(R_0612050 - A)

Repair for new bearing condition.

Revision Set 09.05.12

Latin Quarter Apartments
17747 SE 30th Ave
Portland, OR 97214

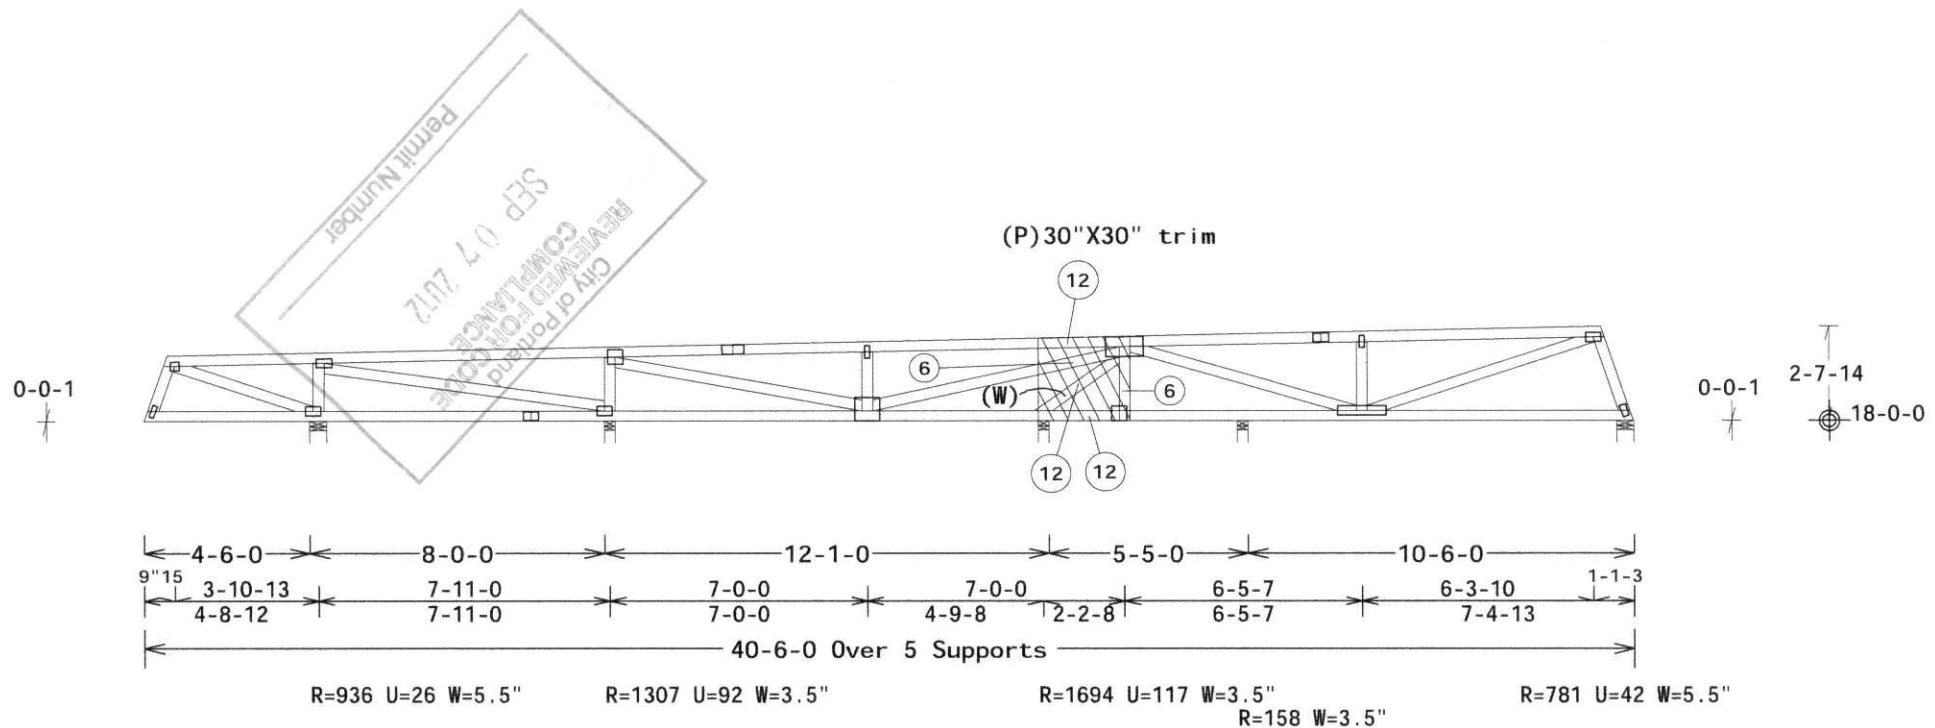
- > Shore truss to restore to pre-loaded condition.
 > Add new web(s) with plywood gussets as specified.
 > Remove shoring.

(W) Add 2X4 HF Std/Stud or better web.

(P) 3/4" Plywood OR 3/4" OSB gussets; APA rated 48/24 sheathing, EXP.1, culled of surface defects if smaller than 24" square. Nail one gusset to each face of truss, through all chord and web members, with 8d (.131"X2.50") nails to alternate faces. Space nails at 3" O.C. and stagger rows to prevent splits. Circles indicate minimum quantity of nails each face.
